South Texas Project Electric Generating Station P.O. Box 289 Wadsworth, Texas 77483

August 19, 2010  
U7-C-STP-NRC-100193

South Texas Project  
Units 3 and 4  
Docket Nos. 52-012 and 52-013  
Revised Response to Request for Additional Information

**RAI 03.08.04-18, Revision 1, Supplement 1****QUESTION:****Follow-up to Question 03.08.04-2 (RAI 2964)**

FIGURE 9A.4-28 RADWASTE BUILDING, FIRE PROTECTION, SECTIONS A-A AND B-B (SHEET 1)

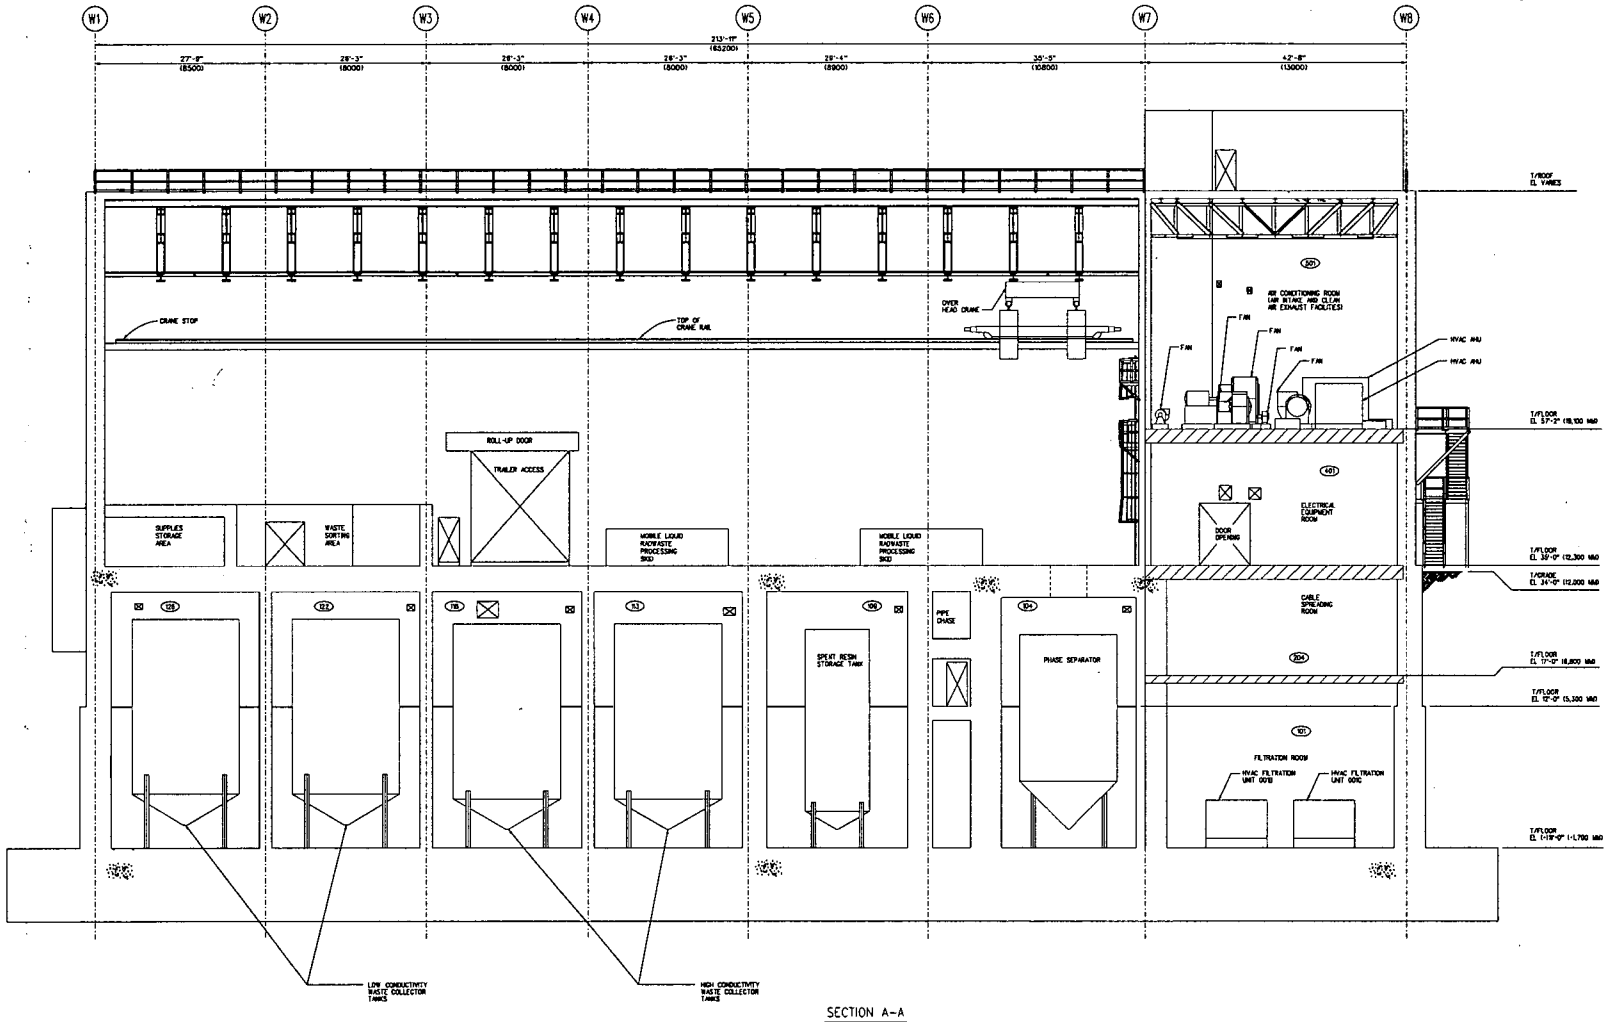
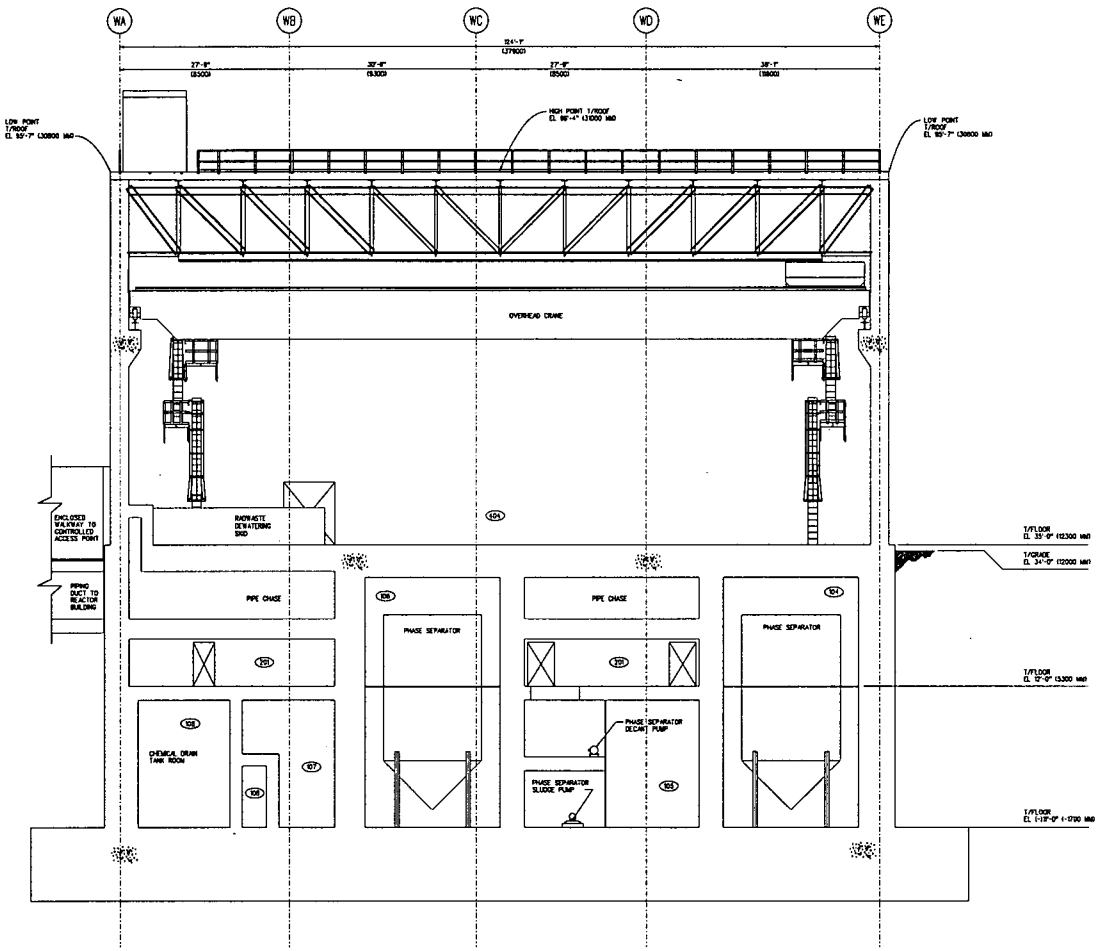
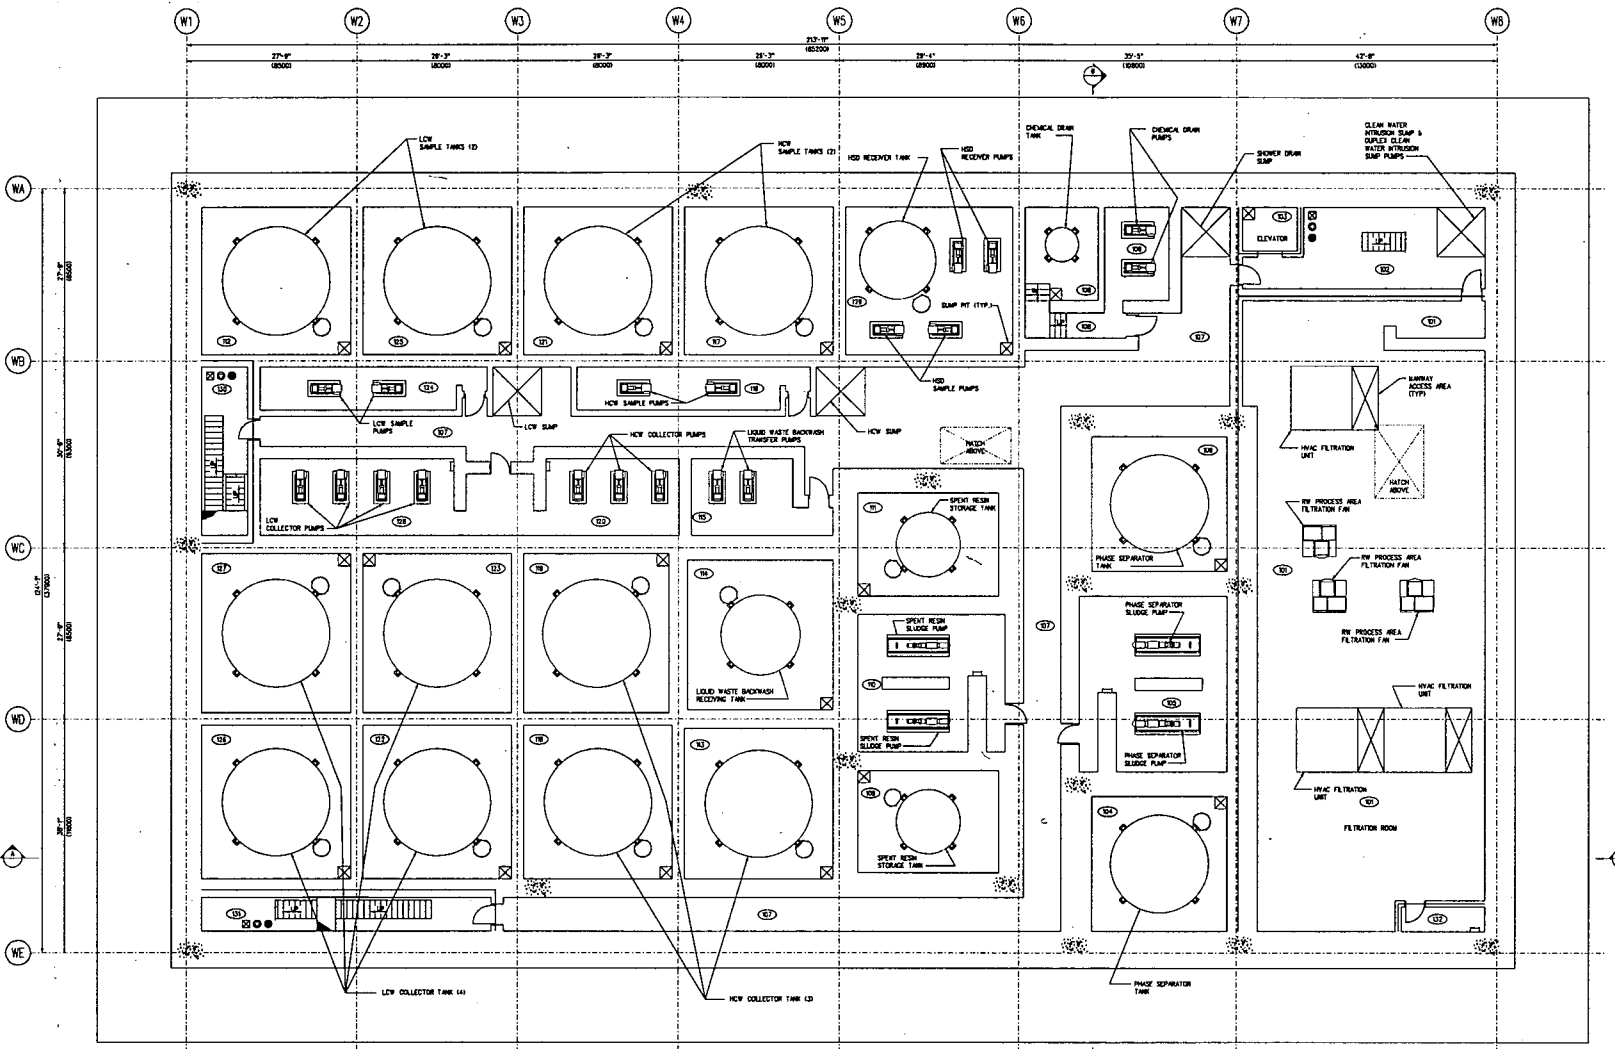
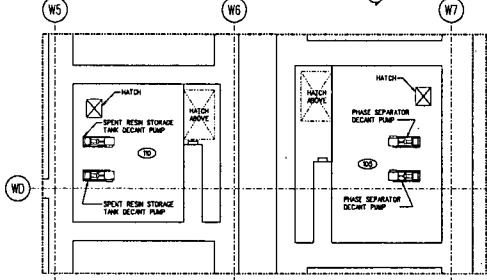
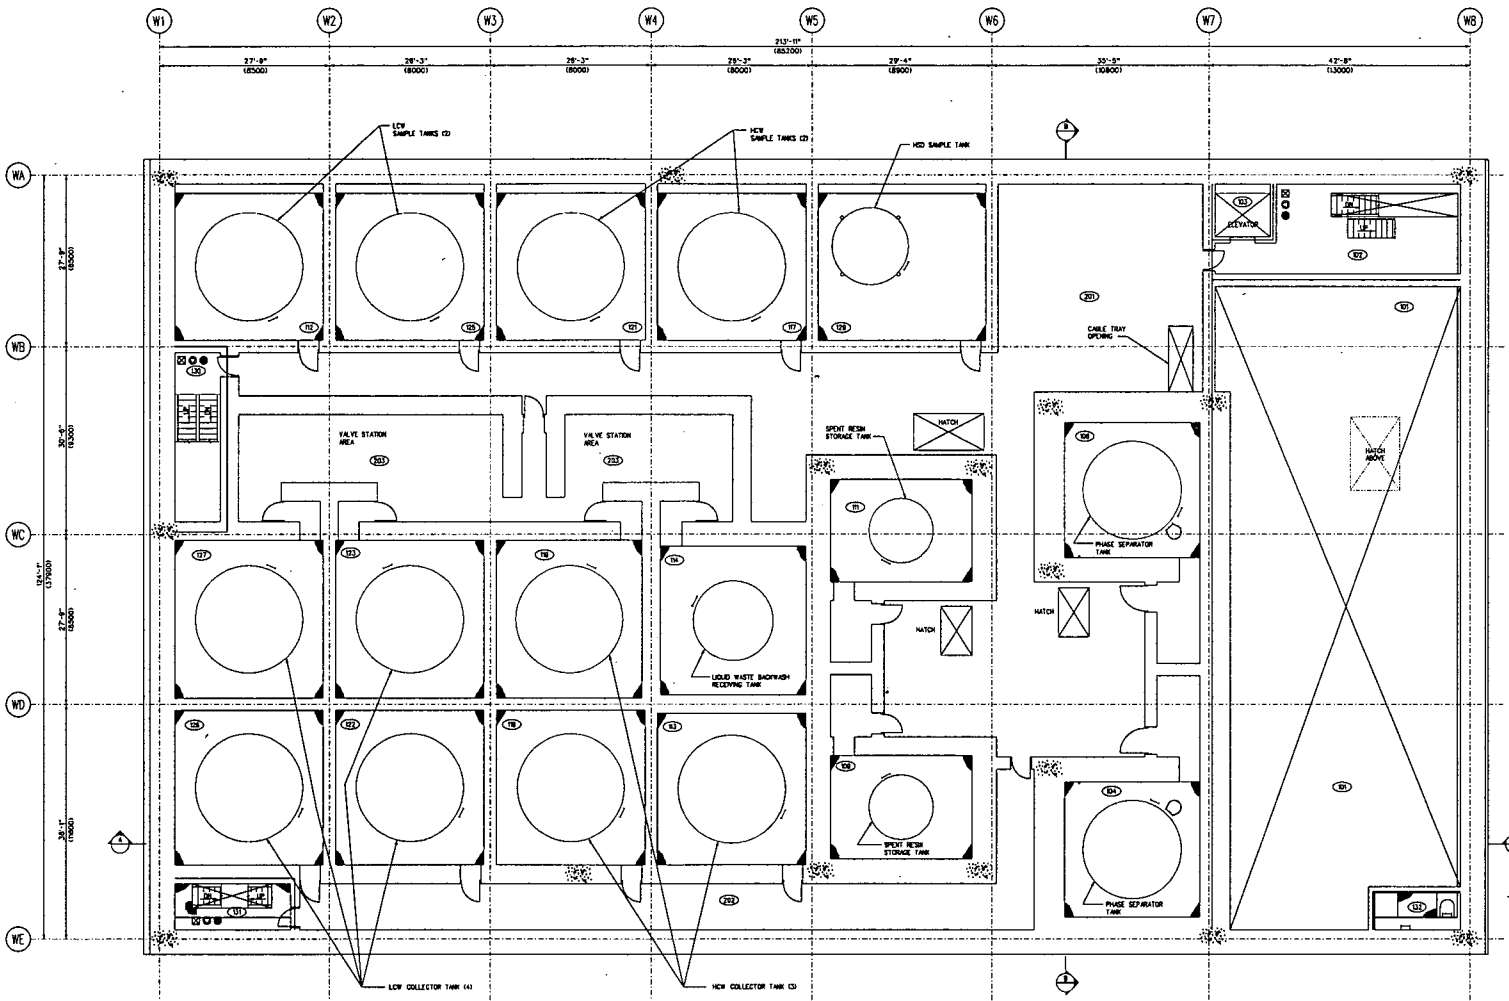
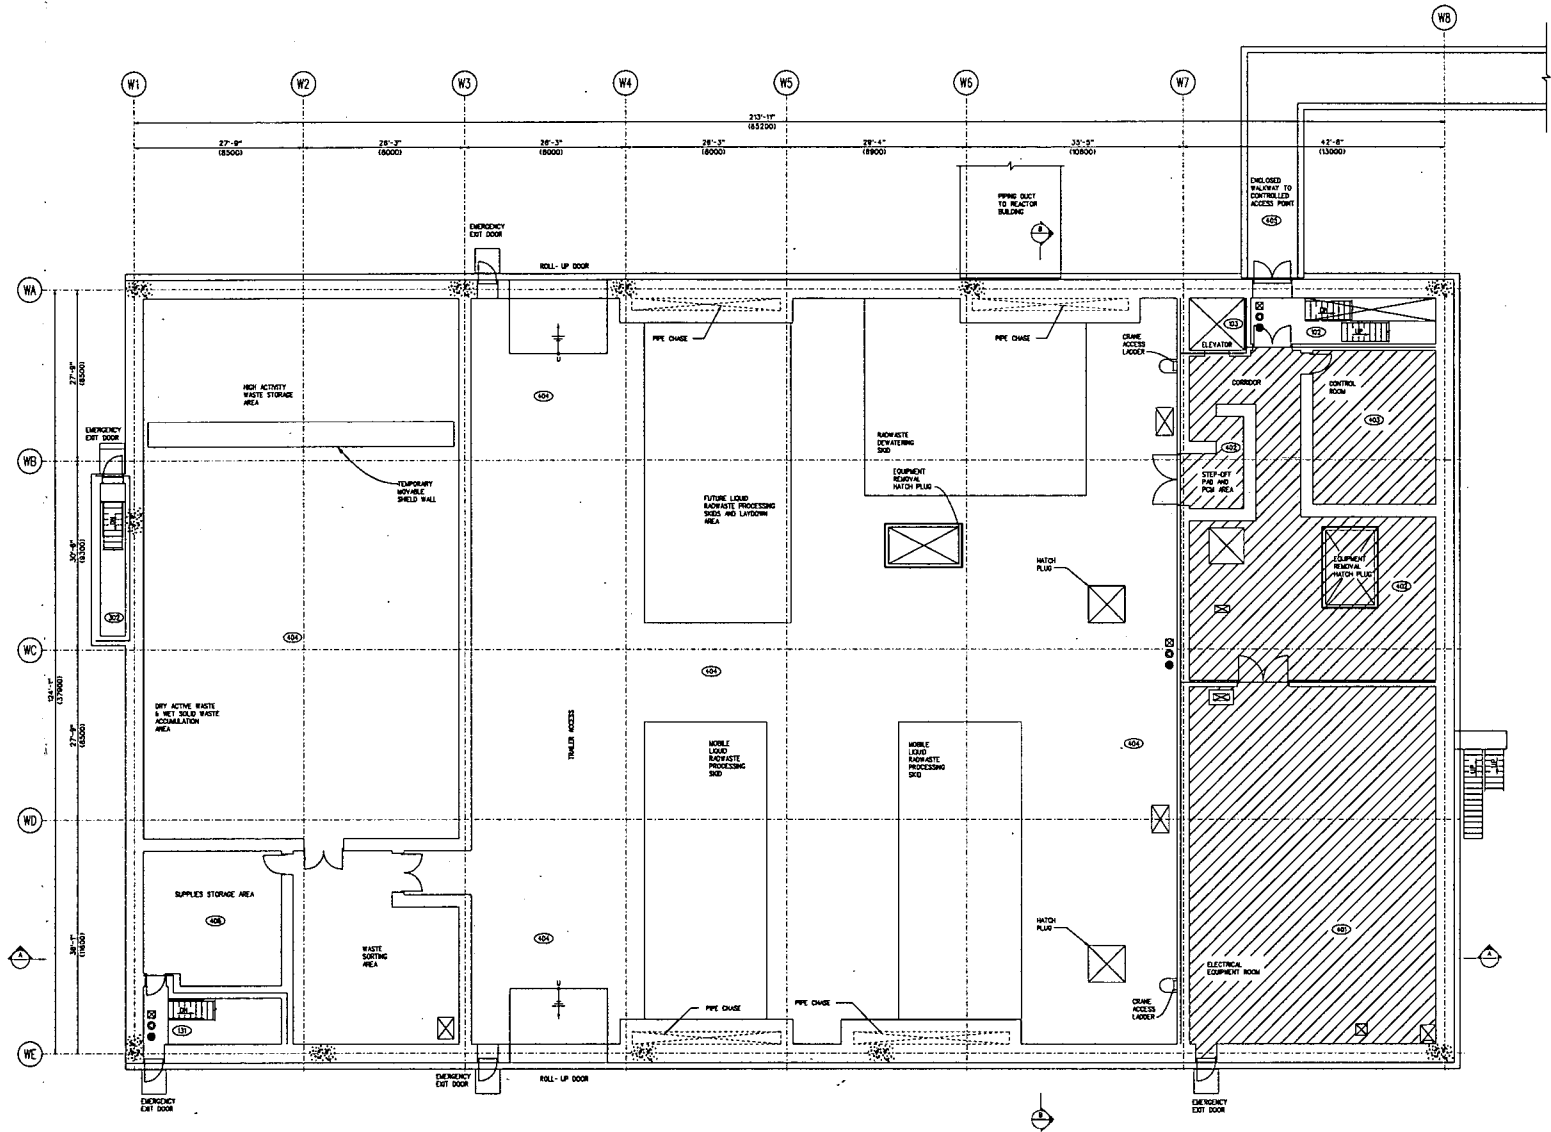
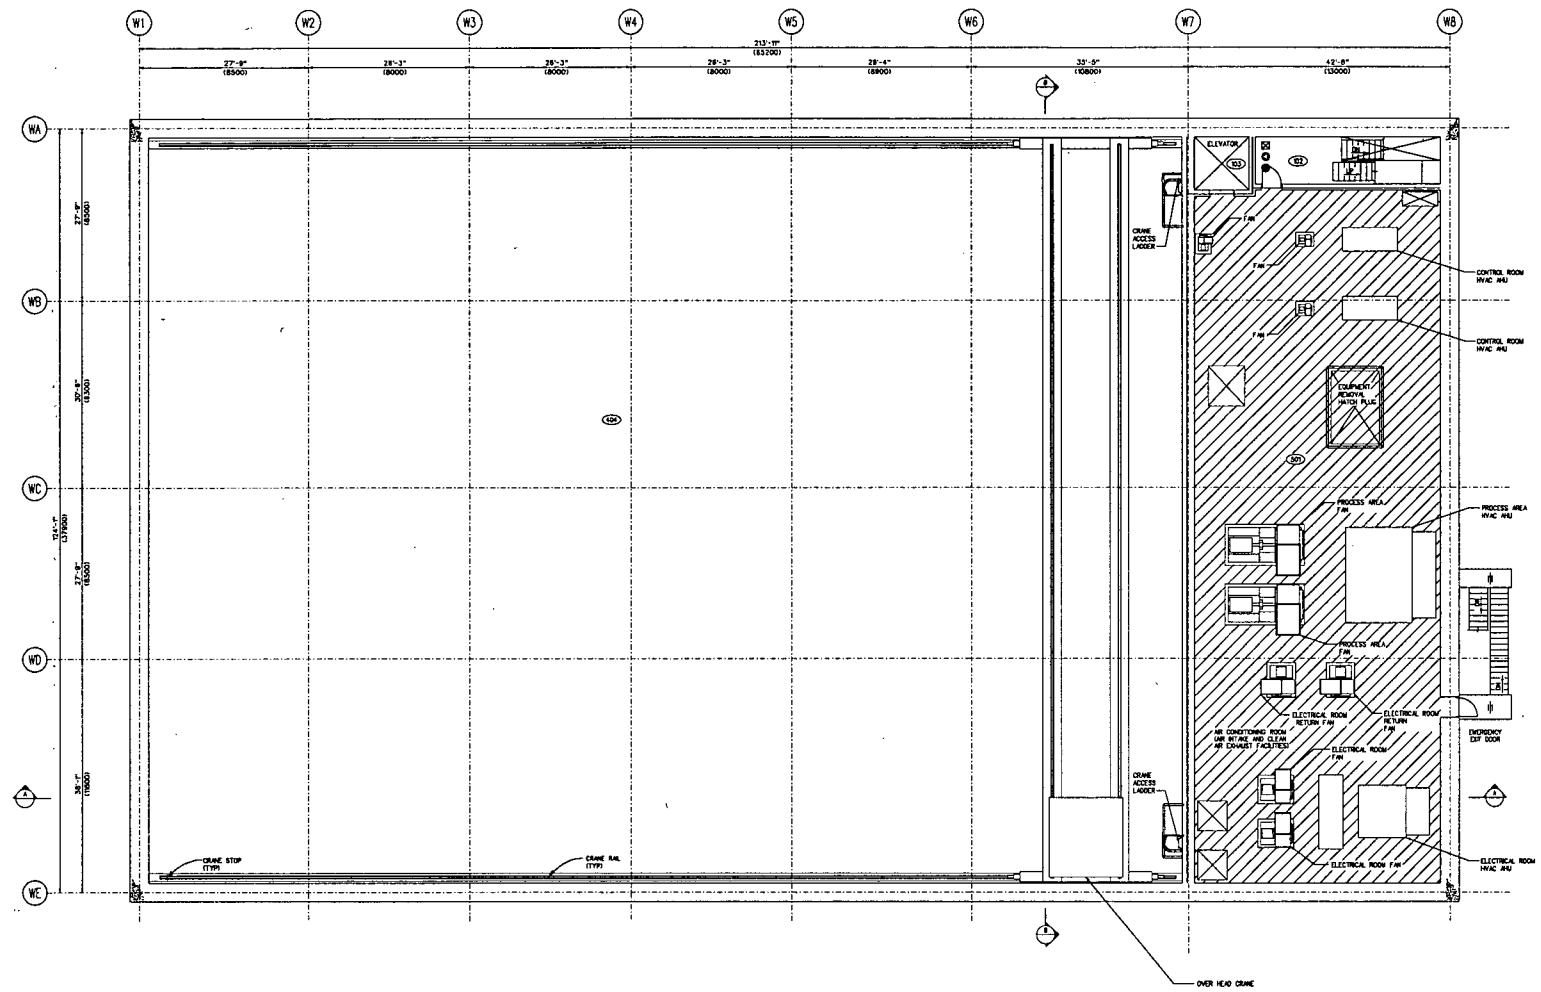
#### **Fire Protection (Figures 9A.4-28 through 9A.4-32)**

The Fire Protection figures for the RWB are revised to reflect some changed locations of hose racks, stand pipes, extinguishers, and fire barriers (walls and floors). None of these items is deleted or added. The relocation is due to the interior reconfiguration of the RWB discussed in Attachment 1. There are no functional changes to the RWB fire protection provisions.
